# **Rebuttal of NYC MTA Platform Screen Door Feasibility study**

Author: Joe Wu, PhD

**Figure 1 – Non-compliant ADA condition**  
Hoyt Street Station

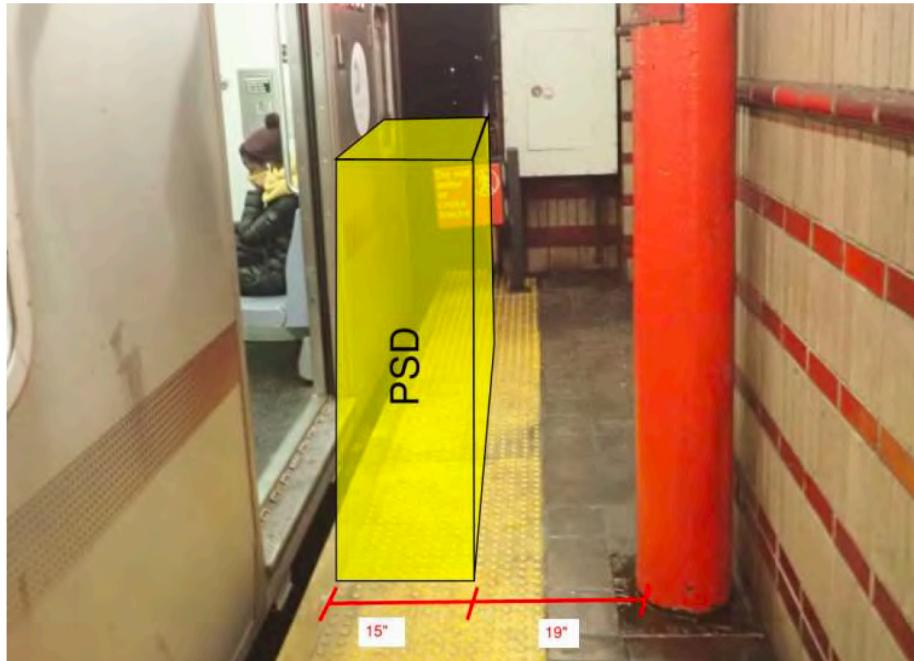
- That section of the platform without the PSD is too narrow for normal passengers to stand or walk on, let alone someone in a wheel chair.
- The pipe is a big obstruction and safety concern as someone may walk on that section of the platform and around the pipe to wait for train effectively walking close to the platform edge.

Figure 1 – Non-compliant ADA condition  
72nd Street Station

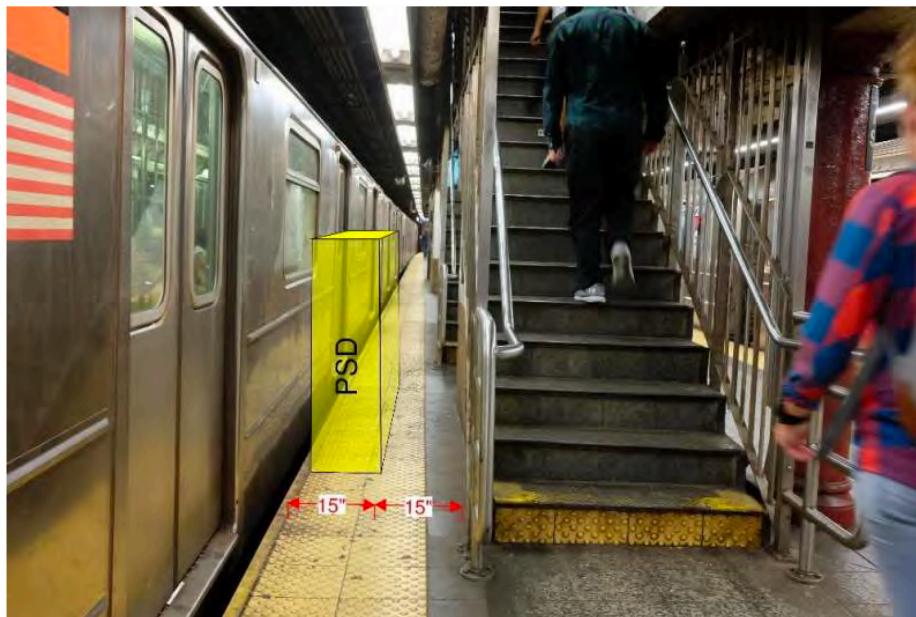
- They cite 36 inches the minimum ADA requirement.
- At 30 inches (15+15) this section of the platform was not compliant with ADA in the first place and is too narrow for passenger traffic regardless of disability status. One foot will touch the yellow no-step line if someone were to walk through that strip of the platform, which goes against MTA's public safety announcement.
- A person in a wheel chair will not be descending to the platform using the stairs.
